Access Compliance Report

Public Rights-of-Way

(Curb Ramps)

Intersection ID: 10028518	Main Street: HOLABIRD_LN	Cross Street: N/A	Location: E
ADA ID: F2B8BBD2F6E7	Ramp Type: BlendTrans1	Initial Pass/Fail: Pass	Overall Compliance: No
Severity Score: 0.25			
Codes/Mitigation Info/Possible Solution		Field Measurements/Component Compliance

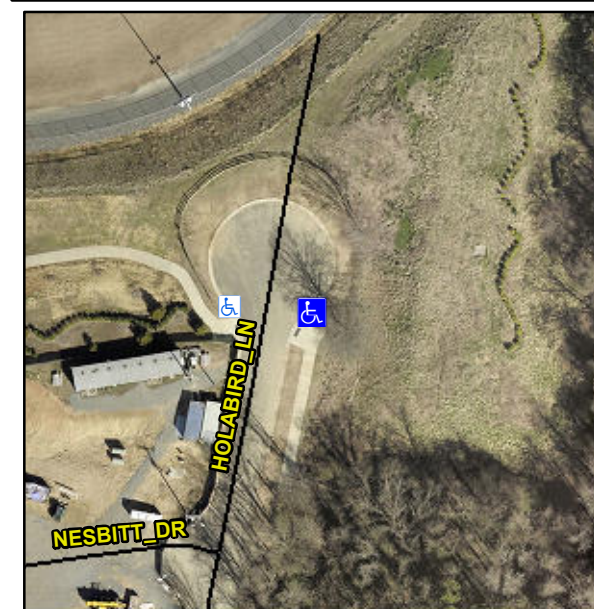
Remove & Replace Detectable Warning System. Remove & Replace Gutter.

R305.2, R304.5.3
